Joe Greenland Centre

Aklavik, NT

TECHNICAL STATUS EVALUATION REPORT

Technical Support Section
Asset Management Division
Department of Public Works and Services
Government of the Northwest Territories, Yellowknife

Photo 1: Potable water tank fill piping.

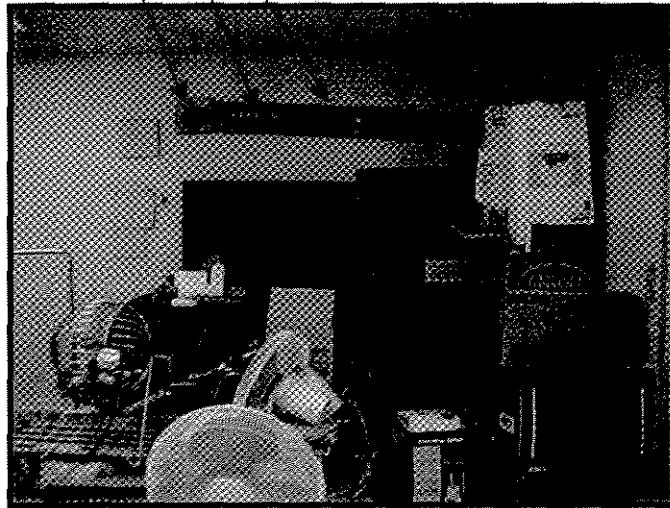
- Most room thermostats are set to the maximum temperature.
- Piping on fill line for domestic water tank is a combination of copper, galvanized iron and ABS.

Replace the galvanized fittings and ABS pipe with approved pipe as shown in *Table A-2.5, 2.6, 2.7* of the *Canadian Plumbing Code*.

Photo 2: Wall not painted during renovation and cord for freezer

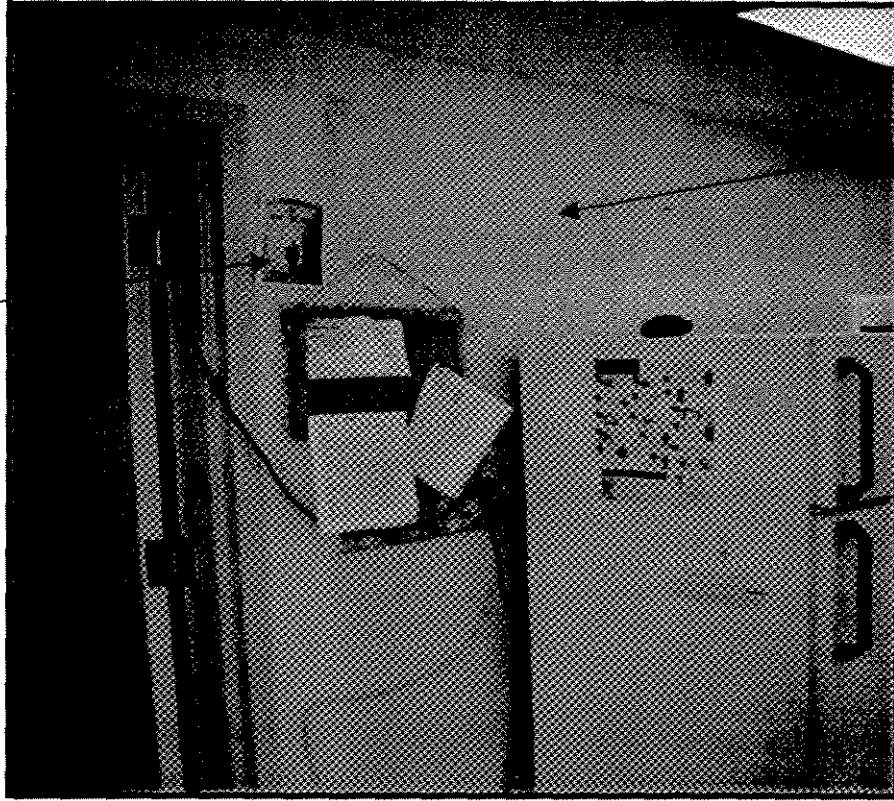
- Door is not fire rated.
- No fire extinguisher in cooking area of kitchen.
- Kitchen is very warm with no cooking taking place. Staff indicated that temperature become unbearable in the summer.
- No exhaust fan has been installed except range hood that cannot move sufficient air to ventilate this area.
- Lights in range hood do not work.
- Dishwasher has not worked for years.
- Movement cracking above door to storeroom.
- Ceiling tiles are damaged.
- Wall areas were left unpainted during renovations carried out in 1996(?).

- Ceramic tile was not sealed to backsplash during 1996(?) renovation.

Photo 3: Exhaust fan in smoking room

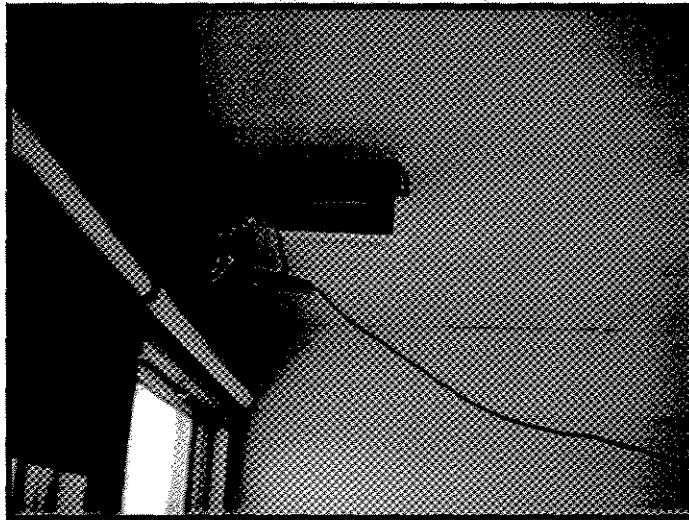
- Cable from satellite dish is running through window.
- Room is not connected to building heating system.
- Smoke exhaust is provided by a recess type bathroom fan surface mounted on the ceiling and powered by an extension cord through sliding doors.
